Product Advisory (PA)

Subject: Change of the standard interior label of Renesas Electronics

Publication Date: December 1, 2022

Gap Points Current and New / Ex-IDT

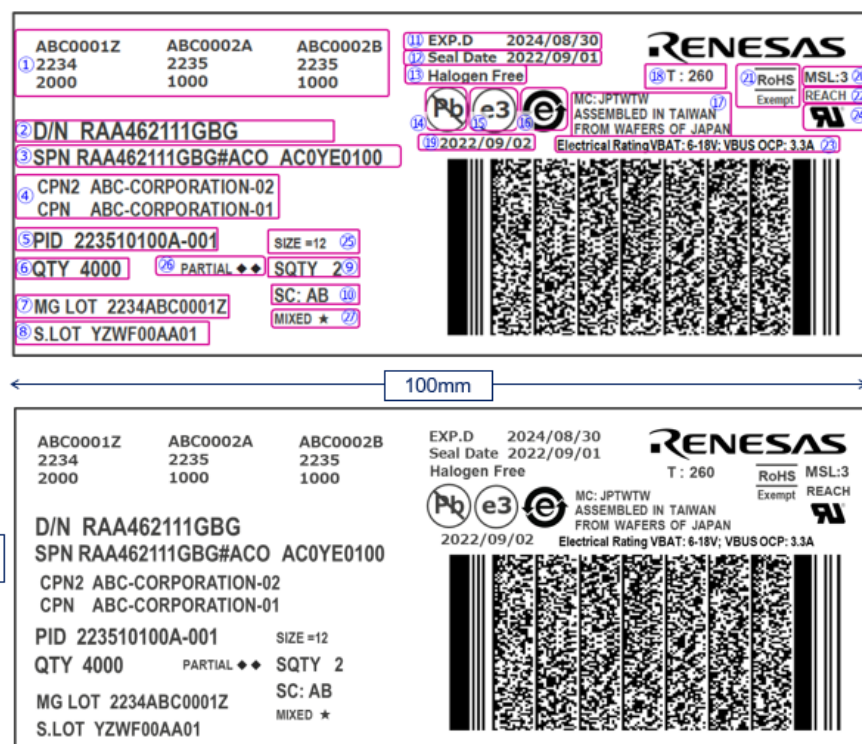
- **Added Items**
 - PID (Traceability Control)
 - S.LOT (Traceability Control)
 - For Renesas Internal Use
- **Design Change Items**
 - SPN (Orderable Parts No.)
 - Lot Combine Information
 - MG LOT (Manufacturing Lot No.)
 - Pb-Free's Logo Mark
 - Country of Origin (Manufacturing Country Info.)
 - PCB On Board Reflow Rank (Peak Temperature)
